SUBJECT: Indian Point 3 Nuclear Power Plant
Docket No. 50-286
Proposed Improved Technical Specifications
Reply to NRC Request for Additional Information

NYPA REPLY TO NRC RAI
REGARDING REVISION 0 OF PROPOSED ITS

Figure 3.10-1

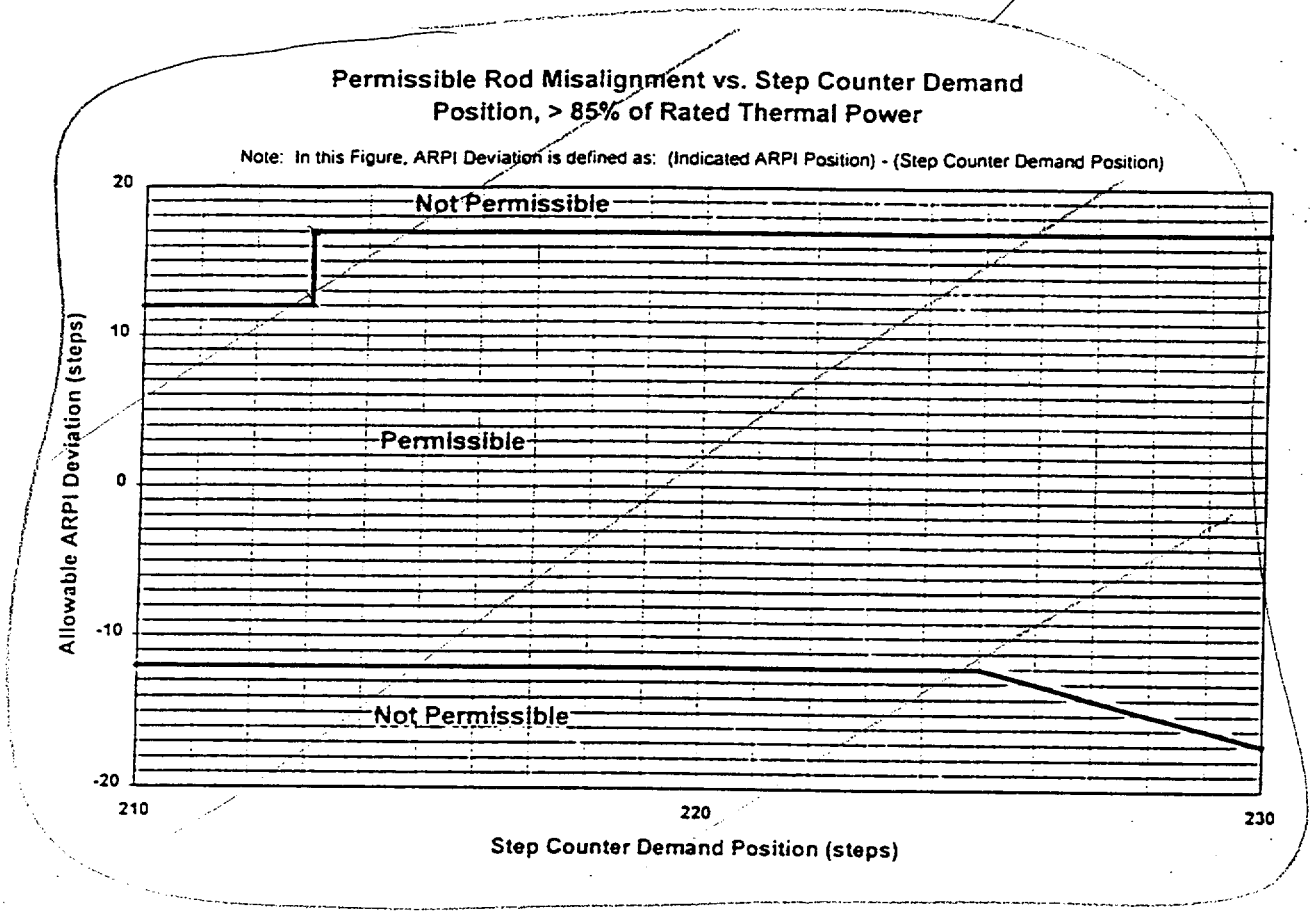
A.15 CTS Figure 3.10-1, added by Amendment 197, establishes limits for the maximum permissible rod misalignment (indicated rod position minus group step counter demand position) when > 85 % RTP. This information is presented in both Table and graphical format, either of which describes the LCO limits. ITS LCO 3.1.4, Table 3.1.4-1, maintains the same limits for permissible rod misalignment; however, the information is presented in Table format only and re-formatted for clarity. This is an administrative change with no impact on safety because there is no change to the limits for permissible rod misalignment.

Figure 3.10-1

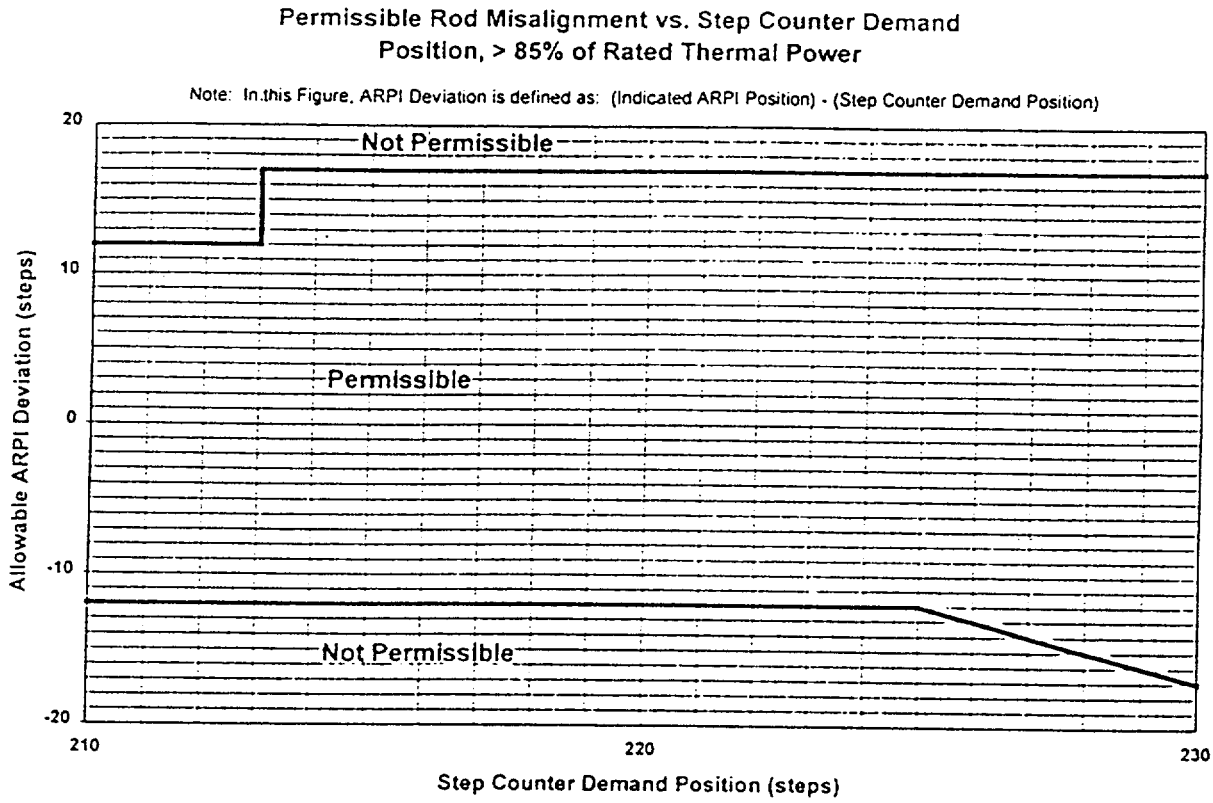
No Impact on ITS 3.2.1

Figure B 3.2.1B-1 (page 1 of 1)
K(Z) - Normalized $F_Q(Z)$ as a Function of Core Height

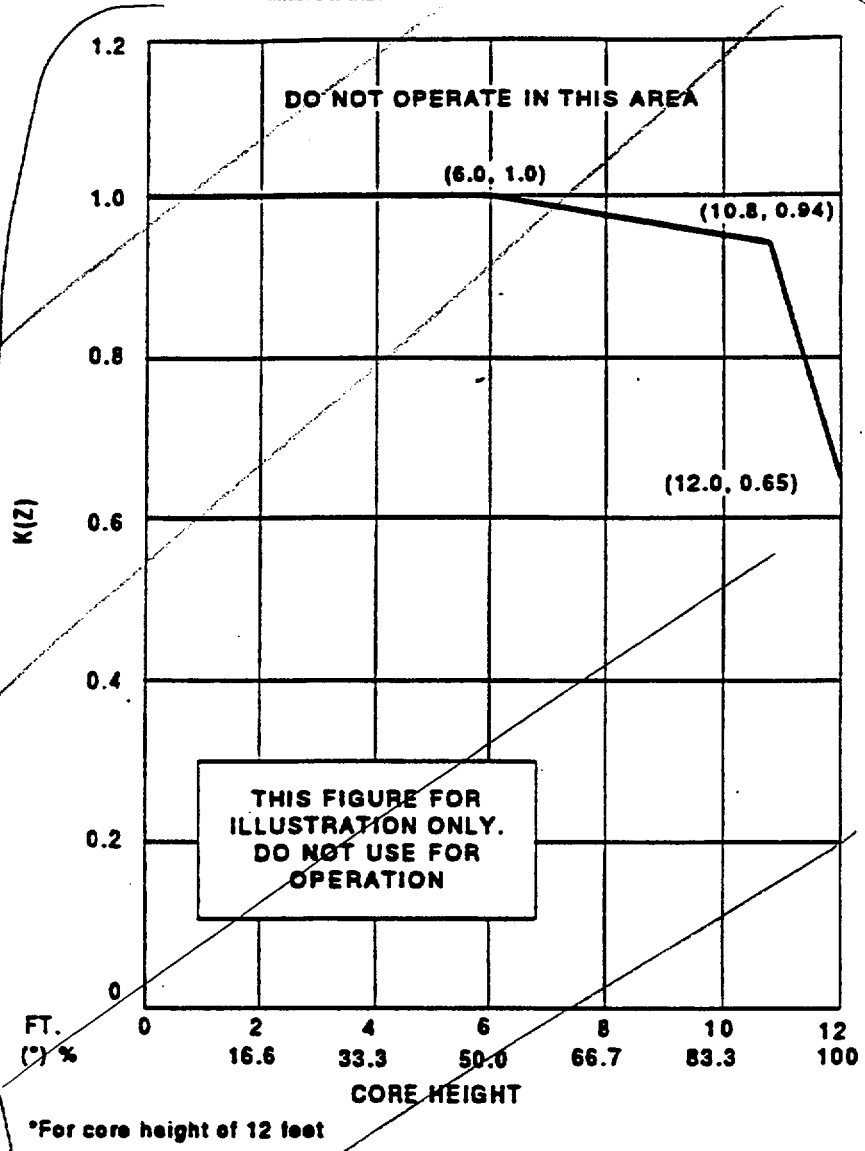
X.1 NUREG-1431, Rev 1, Section 3.2.1, was modified to delete Figure B 3.2.1B-1 because IP3 maintains the Heat Flux Hot Channel Factor ($F_Q(Z)$) limits in the Core Operating Limits Report.
